Enclosed please find the Vehicle Safety Defect Initial Information Reports, regarding the Recall Campaign, Number 162, which we are initiating in order to correct the following:

VEHICLE SAFETY DEFECT
INITIAL INFORMATION REPORT
F355 FI SPIDER FUEL TANK INSPECTION
RECALL No. 162

SUBJECT : Ferrari F355 Fuel Tank Inspection Recall No. 162/1

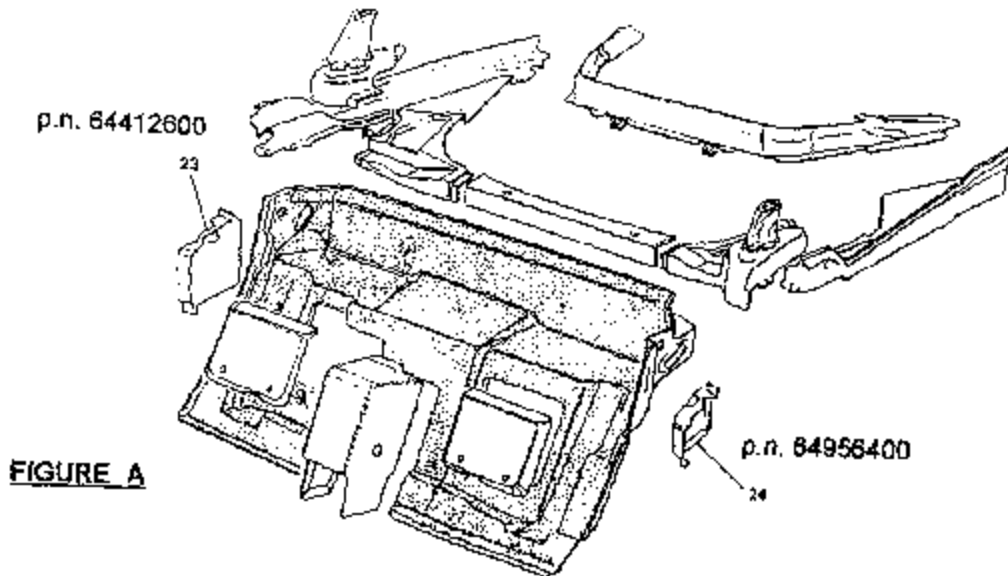
- 1 Disconnect battery (main switch).
- 2 Unscrew self-tapping lower fixing screws which attach interior covers p.n. 64412600 and p.n. 64956400 (reference item # 23 and item # 24 in figure A).
- 3 Cover rear fenders with fender covers.
- 4 Remove fuel tank fill cap to release pressure from the fuel tank.
- 5 Take the fuel cap p.n. 4816 and drill a hole in the center to enable the fitting of a nipple in order to connect a hand held pump with pressure gauge. We would suggest the use of a suitable coolant system pressure tester. The coolant tank fitting will have to be removed and the drilled fuel cap with fitting attached.
- 6 Check all connections between pressure gauge and fuel cap.

- 11 Remove modified fuel cap and the hose clamping pliers used in step 10.
- 12 Re-install the original fuel filler cap.
- 13 Re-attach battery (main switch).
- 14 Verify the length of the screws removed in step 2 (reference item # 23 and item # 24 in figure A) If they are 16mm in length, they may be reused. If they are 22mm in length, use new 16mm screws supplied under p.n. 4815.

FIGURE B

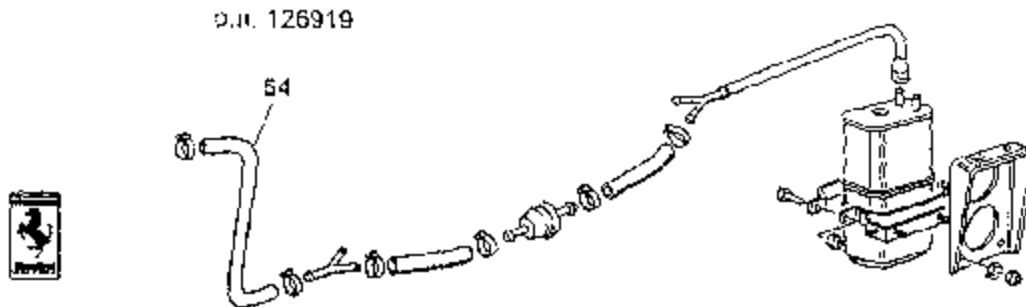
- 7 Install the modified fuel cap onto the fuel filler neck, making sure it is properly sealed.
- 8 Using adequate hose clamp pliers, compress the hose p.n. 126919 (reference fuel line #54 in figure B.) This operation is necessary in order to avoid any loss of pressure during the test.

- 10 Keep the system under pressure for at least 15 minutes, monitoring the pressure gauge. If no drop of pressure is noticed within that period of time, damage to the fuel tank can be excluded. Otherwise, it will be necessary to remove the fuel tank for inspection as per the attached instructions.

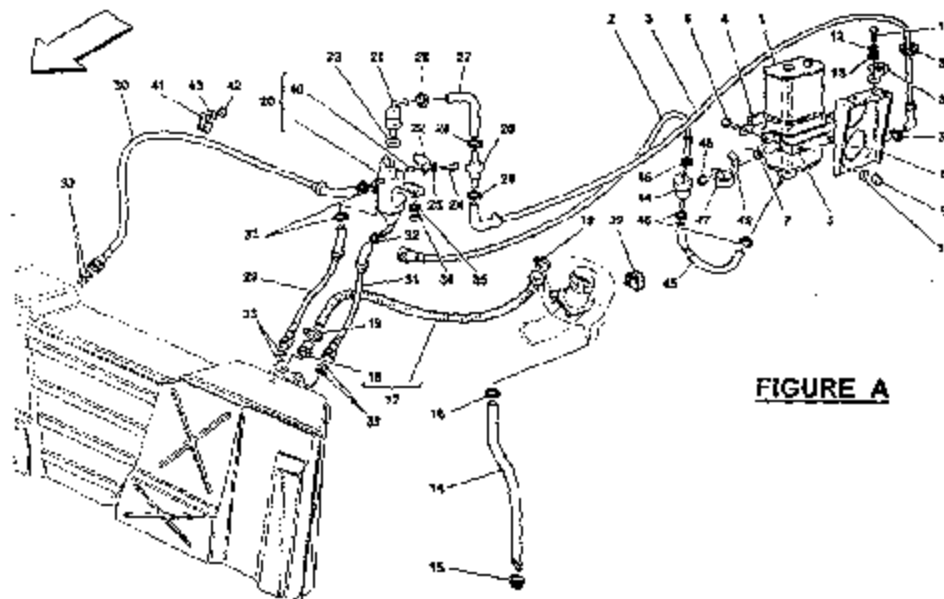
- 1 Disconnect battery (main switch).
- 2 Cover rear fenders with fender covers.
- 3 Remove fuel tank fill cap to release pressure from the fuel tank.
- 4 Lift vehicle and remove fuel tank access panel. Drain the fuel from the tank into an approved fuel container.
- 5 Remove fuel tank vapor lines at top of fuel tank utilizing special tool part number 95970126. (Items No.30, No.29, No. 31, and No.17 In figure A)

FIGURE B

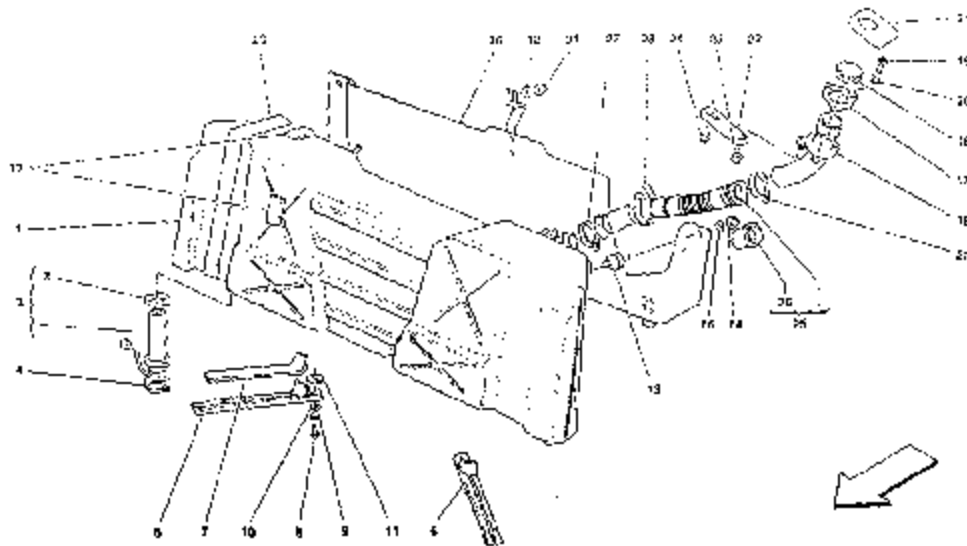
- 6 Loosen fuel tank fill tube clamp at top and disconnect tube from fuel tank. (Item No.27 in figure B)
- 7 Remove fuel supply and return lines from fuel pump assembly.
- 8 Shift gear box into third gear and disconnect shift rod under fuel tank.
- 9 Place a transmission type jack under the fuel tank and remove fuel tank securing straps.
- 10 Drop the fuel tank taking care to disconnect the fuel pump connections and to take note of the fuel line routing through the chassis.
